UNITED STATES PATENT AND TRADEMARK OFFICE

Office Action Summary	Application No. 10/764,139	Applicant(s) DURON, PAUL P.	
	Examiner Samuel E. Belt	Art Unit 3746

DETAILED ACTION

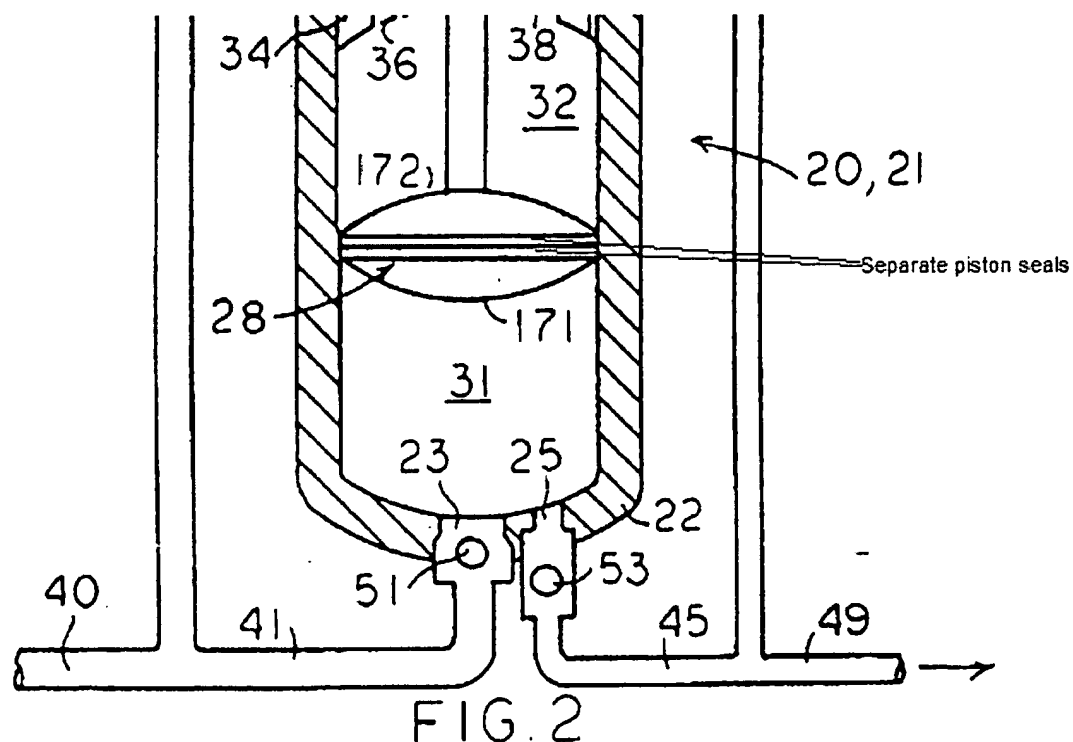
Gram discloses a double-acting, reciprocating piston, high pressure, cryogenic pump comprising; a cylinder; a piston rod (Figure 2, item 30); a pair of spaced apart piston heads (Figure 2, items 171, 172) on said piston rod; a venting passageway for venting blow-by vapors or fluids between the piston heads (column 9, lines 26 +, see note); whereby blow-by vapors or fluids are reclaimed and do not interfere with normal operation of said cryogenic pump; each of the piston heads having a separate seal

(Notes: The examiner is interpreting both piston faces 171 & 172 as being separate "piston heads" which are both mounted onto the same piston rod and each has its own separate seals, see figure below.

FIG. 1

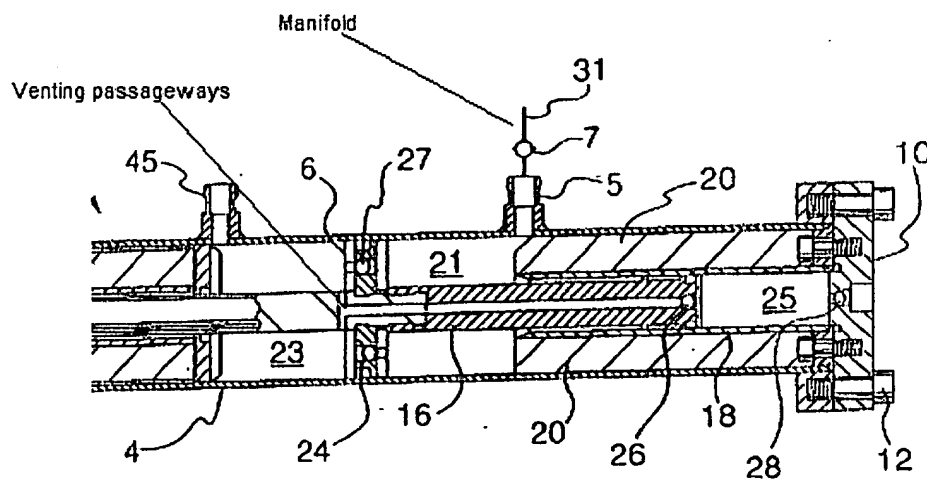
which is substantially analogous to the claimed invention. The Gram and Schuck device differs from the claimed invention in that there is no explicit teaching of the piston rod having a through passageway for venting the vapor or fluid. Gram et al. teach a pump having a piston rod with a through passage (see paragraph [0075]).

In regards to claims 6-9 please refer to figure below for further clarification of the Gram et al. reference.
